ORE - TRAFFIC: January 2026 Proposed SDMM Updates Summary

STANDARD SIGN DESIGN

ODOT - OFFICE OF TRAFFIC OPERATIONS

CODE NO.: R13-H2

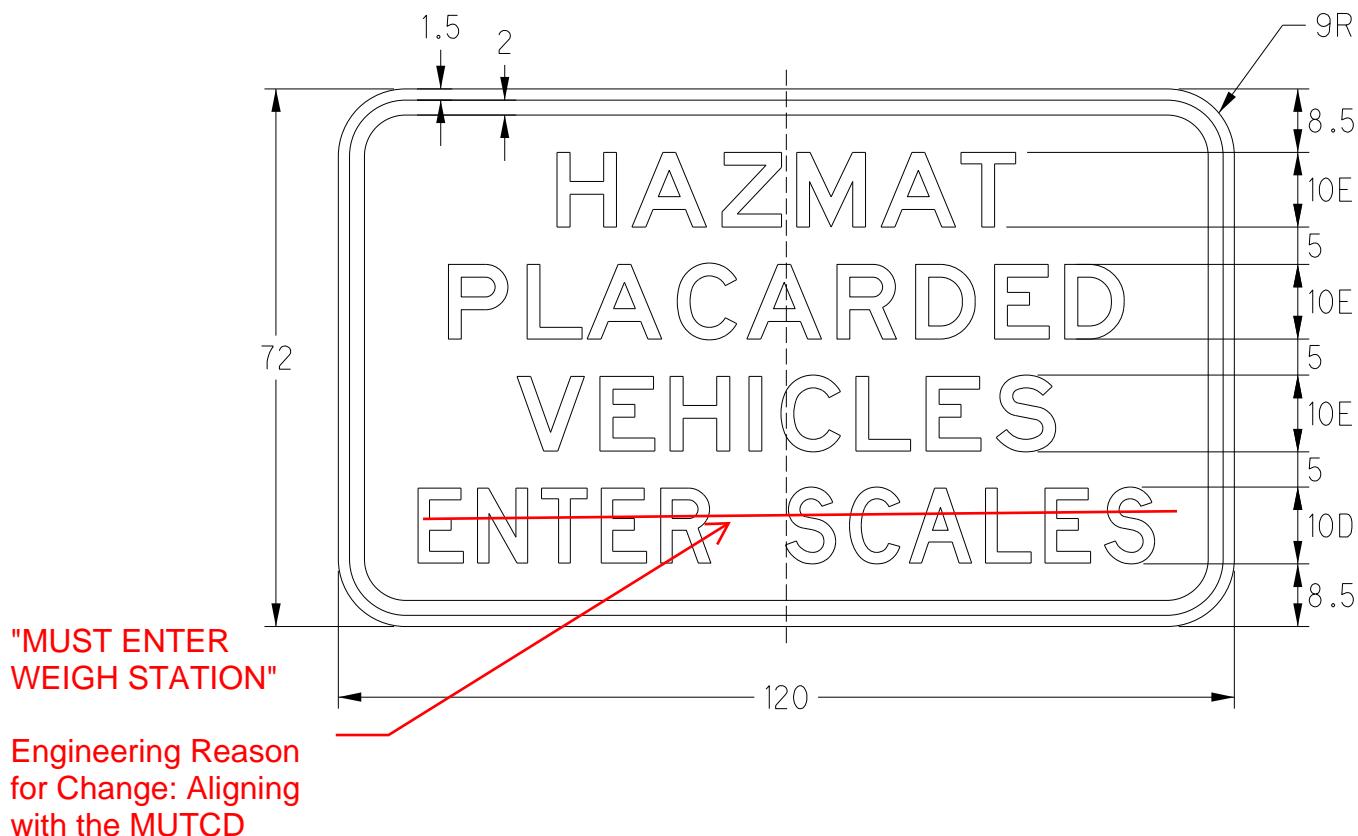
| Revision Type | Reference | Section Description (Red indicates Change of name from existing) | Description of Revision | New or Deletion | Primary POC |
|---------------|-----------|-------------------------------------------------------------------------------------------|---------------------------------------------------------------------------------------------------------------------------------------------------------------------|-----------------|-------------|
| SDMM | R13-H2 | HAZMAT PLACARDED VEHICLES ENTER... | Change ENTER SCALES to MUST ENTER WEIGH STATION | | Eberhardt |

R16-H1

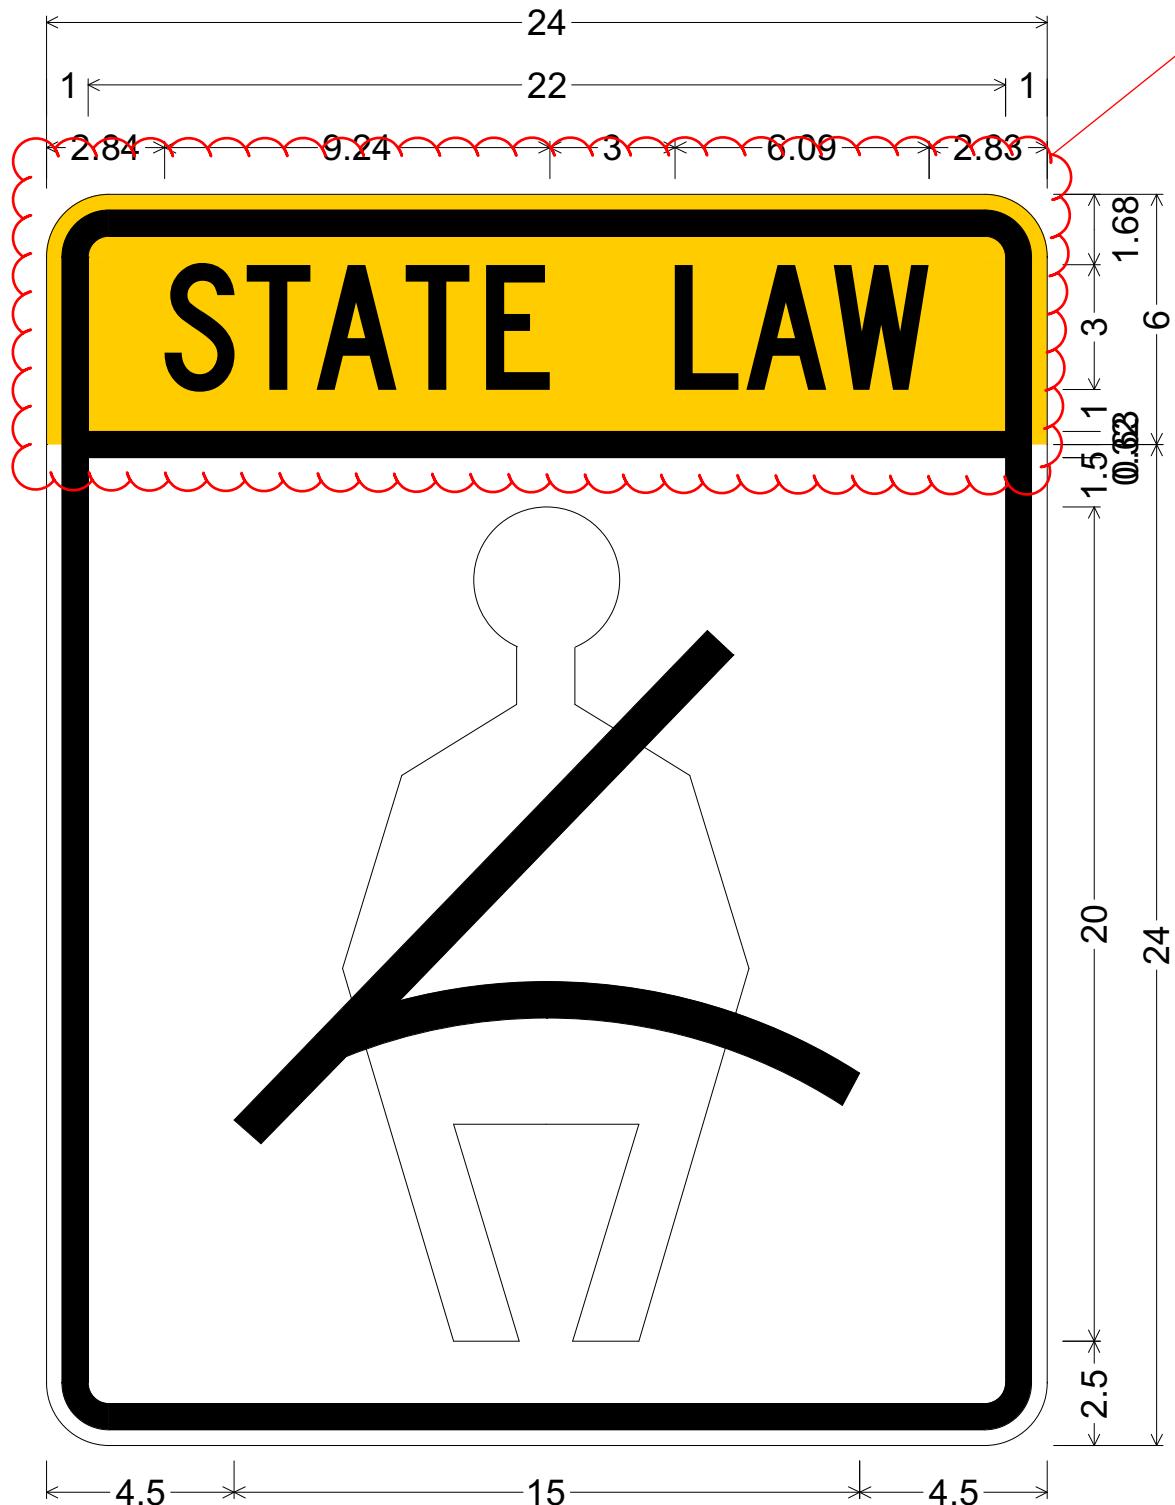
| Revision Type | Reference | Section Description (Red indicates Change of name from existing) | Description of Revision | New or Deletion | Primary POC |
|---------------|-----------|-------------------------------------------------------------------------------------------|---------------------------------------------------------------------------------------------------------------------------------------------------------------------|-----------------|-------------|
| SDMM | R16-H1 | <i>STATE LAW / (Seat belt symbol) / STATE LAW</i> | Redesign to place "STATE LAW" at top of sign and as black on yellow | | Soisson |

Add Yellow "STATE LAW" to top, remove from the bottom

1.50" Radius, 0.63" Border, 0.38" Indent, Black on Yellow;
"STATE LAW", C 2K;

1.50" Radius, 0.63" Border, 0.38" Indent, Black on White;

CODE NO.: R16-H3

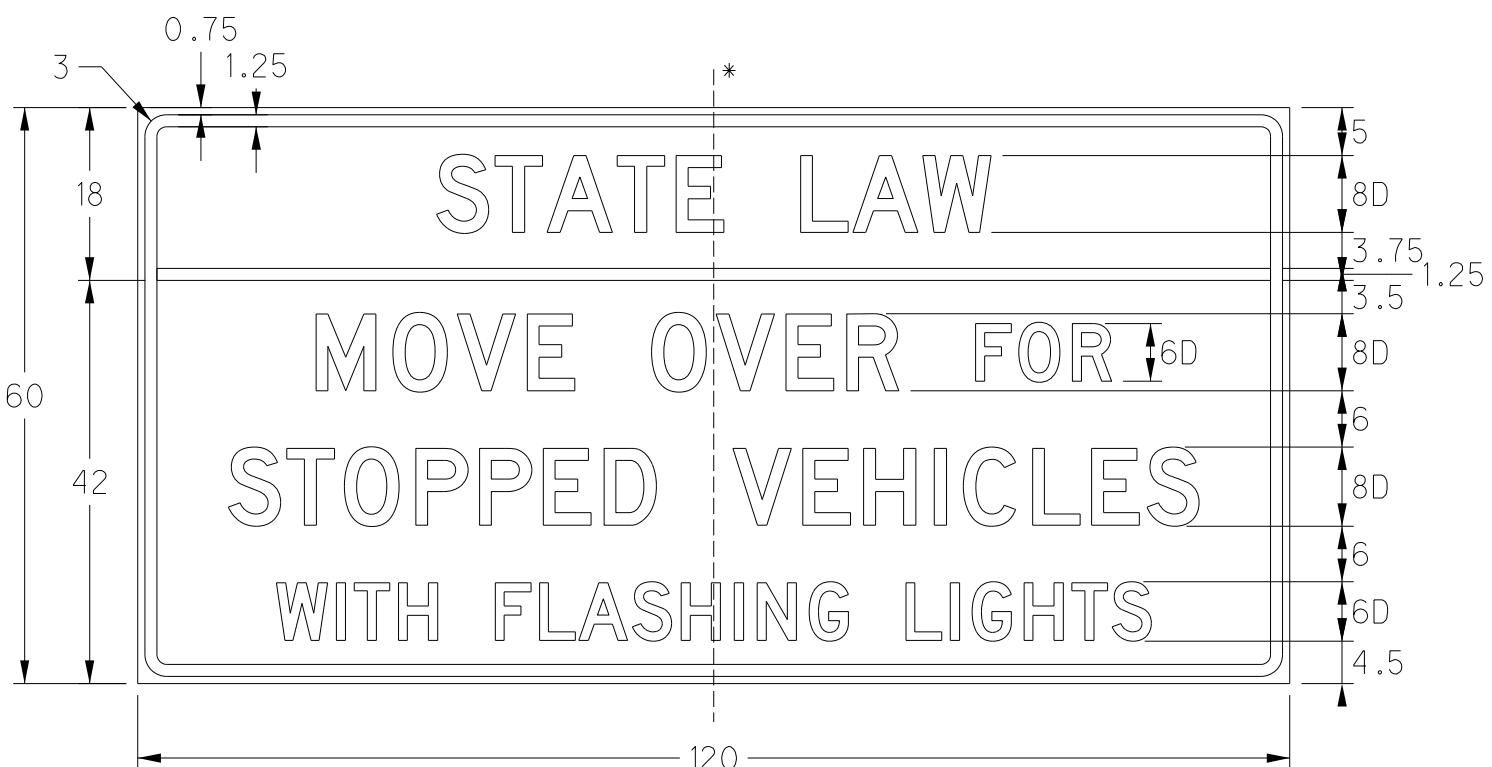
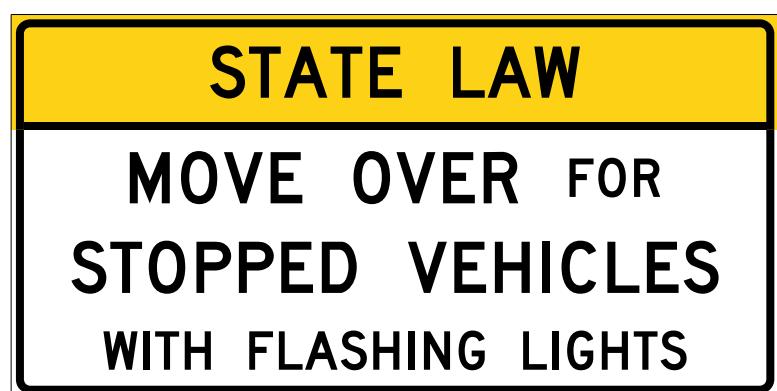
| Revision Type | Reference | Section Description (Red indicates Change of name from existing) | Description of Revision | New or Deletion | Primary POC |
|---------------|-----------|-------------------------------------------------------------------------------------------|---------------------------------------------------------------------------------------------------------------------------------------------------------------------|-----------------|-------------|
| SDMM | R16-H3 | STATE LAW / MOVE OVER.... | Revised sign to provide State Law in black on yellow at top of sign | | Soisson |

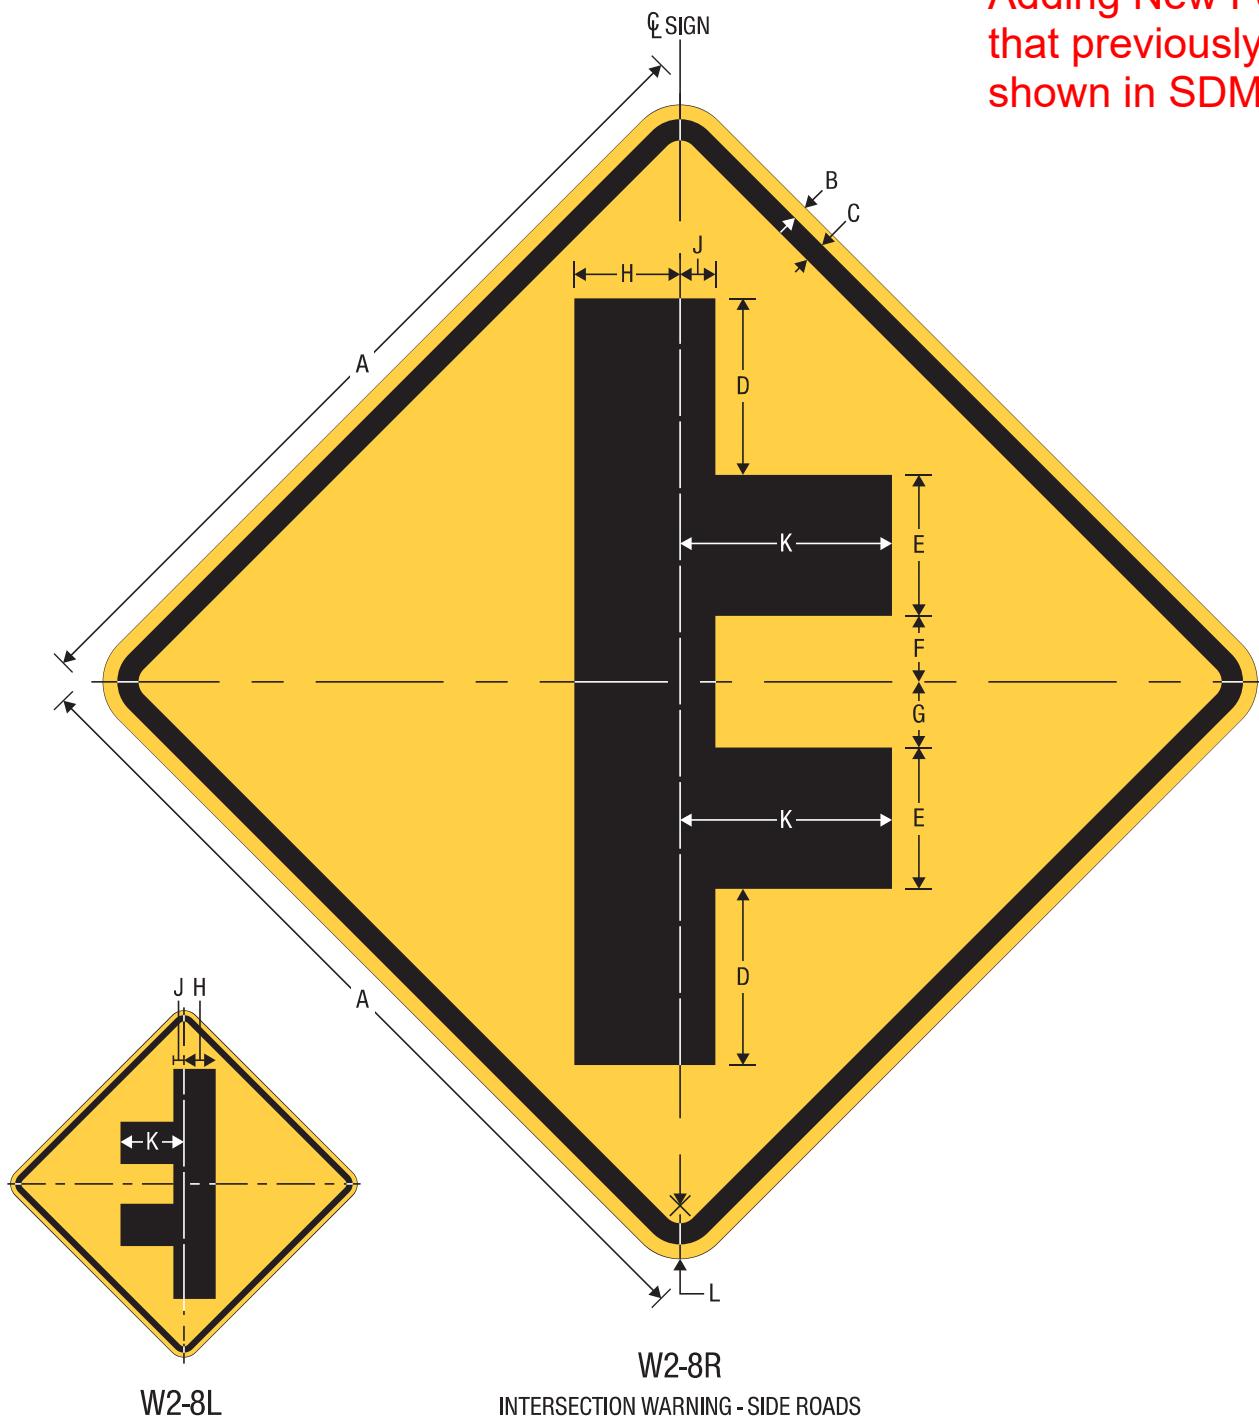
| Revision Type | Reference | Section Description (Red indicates Change of name from existing) | Description of Revision | New or Deletion | Primary POC |
|---------------|-----------|------------------------------------------------------------------|----------------------------------------------------------------------------------------------------------------------------------------------------------------------------|-----------------|------------------|
| SDMM | W2-8 | Intersection Warning - Side Roads | Adding Federal Sign that was previously missing into SDMM | | Soisson |

Adding New Fed sign
that previously was not
shown in SDMM

CODE NO.: W24-H2a

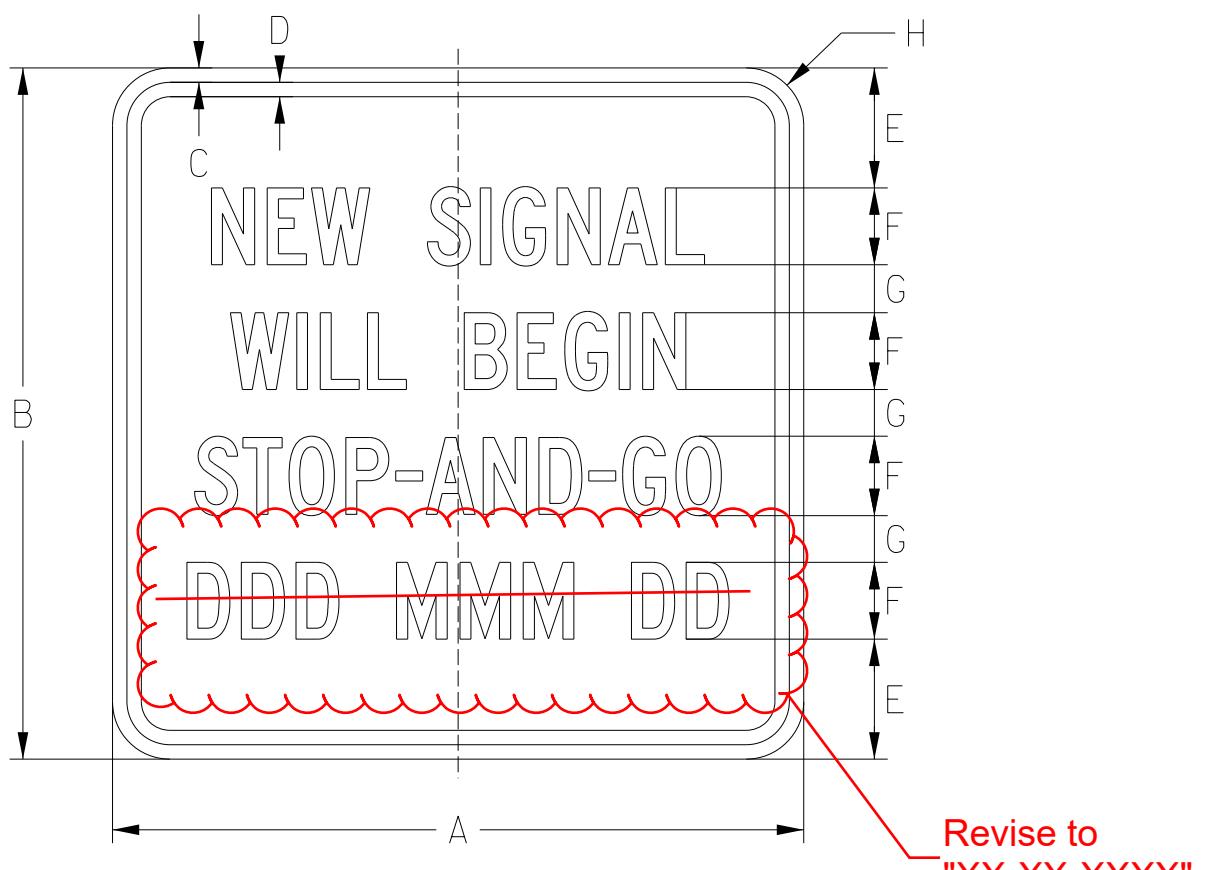
| Revision Type | Reference | Section Description (Red indicates Change of name from existing) | Description of Revision | New or Deletion | Primary POC |
|---------------|-----------|------------------------------------------------------------------|----------------------------------------------------------------------------------------------------------------------------------------------------------------------------|-----------------|------------------|
| SDMM | W24-H2a | NEW SIGNAL WILL BEGIN STOP-AND-GO / (date) xx-xx-xxxx | Revise to display Date as "XX-XX-XXXX" rather than "DAY MO DATE" | | Eberhardt / Beck |

BOTTOM LINE OF LEGEND SHALL READ: ~~DAY MONTH DATE~~

Show updated Sign

XX-XX-XXXX = MM-DD-YYYY

(e.g., 07-04-2025)

CODE NO.: W24-H2d

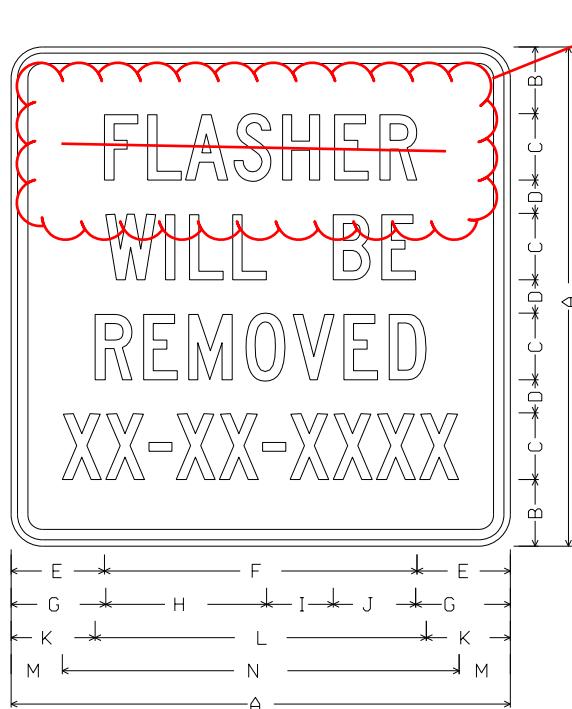
| Revision Type | Reference | Section Description (Red indicates Change of name from existing) | Description of Revision | New or Deletion | Primary POC |
|---------------|-----------|------------------------------------------------------------------|----------------------------------------------------------------------------------------------------------------------------------------------------------------------------|-----------------|------------------|
| SDMM | W24-H2d | FLASHER BEACON WILL BE REMOVED xx-xx-xxxx (date) | Update sign legend to indicate "BEACON WILL BE REMOVED" rather than "FLASHER WILL BE REMOVED". Also show example sign as black on orange (keep option for black on yellow) | | Eberhardt / Beck |

Keep Black on Yellow as
option but show example
sign as Black on Orange

Adjust E and F if necessary
with new legend

CODE NO.: W24-H2e

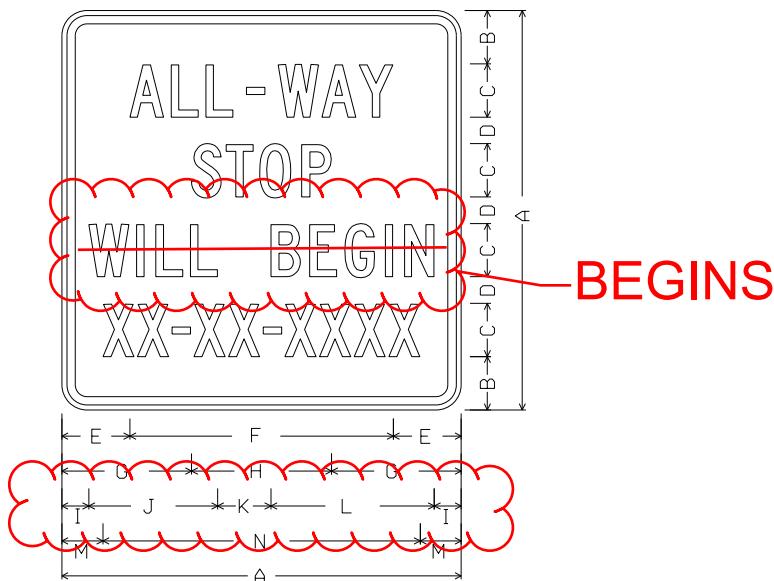
| Revision Type | Reference | Section Description (Red indicates Change of name from existing) | Description of Revision | New or Deletion | Primary POC |
|---------------|-----------|------------------------------------------------------------------|----------------------------------------------------------------------------------------------------------------------------------------------------------------------------|-----------------|------------------|
| SDMM | W24-H2e | ALL-WAY STOP WILL BEGINS xx-xx-xxxx (date) | Modify legend to say, "ALL-WAY STOP BEGINS xx-xx-xxxx". Also show example sign as black on orange (keep option for black on yellow) | | Eberhardt / Beck |

These can renamed K & L

Update to reflect revised legend
